Access Compliance Report

Public Rights-of-Way

Intersection ID: 12355	Main Street: MONUMENT_ST	Cross Street: GREENLAND_AV	Location: NW
ADA ID: 5CC362275D4E	Ramp Type: PerpDiag	Initial Pass/Fail: Fail	Overall Compliance: No
		Severity Score: 35

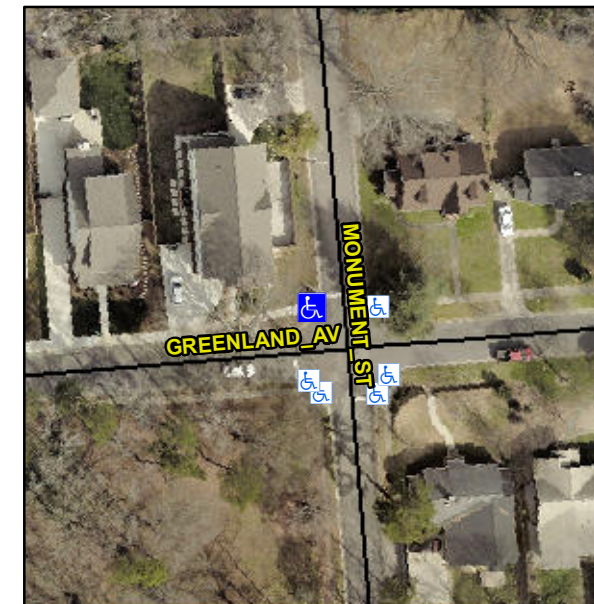
R304.5.1, R304.2.2, R304.5.3

Compliance	Description	Data	Compliance	Description	Data
N/A	Ramp Length (in)	44.0	No	Ramp Slope (%)	13.7
No	Ramp Width (in)	40.0	No	Ramp XSlope (%)	2.9
N/A	Flare Type LT	N/A	N/A	Flare Type RT	N/A
N/A	Flare Slope LT (%)	N/A	N/A	Flare Slope RT (%)	N/A
N/A	Flare Traversable LT?	N/A	N/A	Flare Traversable RT?	N/A
N/A	Landing Length (in)	N/A	N/A	DWS Provided?	N/A
N/A	Landing Width (in)	N/A	N/A	DWS Contrast?	N/A
N/A	Landing Slope (%)	N/A	N/A	DWS Length (in)	N/A
N/A	Landing X Slope (%)	N/A	N/A	DWS Full Width?	N/A
N/A	Landing Curb? (Y/N)	N/A	N/A	DWS Offset (in)	N/A
N/A	Shared Landing?	N/A			
N/A	Gutter Ponding?	N/A	N/A	Gutter Slope (%)	N/A
N/A	Gutter Lip Ht (in)	N/A	N/A	Gutter X Slope (%)	N/A
N/A	Painted X Walk1?	No	N/A	Painted X Walk2?	No
	X Walk 1 Direction	To S		X Walk 2 Direction	To E
N/A	X Walk 1 Width (in)	N/A	N/A	X Walk 2 Width (in)	N/A
	X Walk 1 Slope (%)	2.5		X Walk 2 Slope (%)	0.3
	X Walk 1 X Slope (%)	2.5		X Walk 2 X Slope (%)	3.6

Remove & Replace Curb Ramp With Two New Directional Ramps or Equivalent.
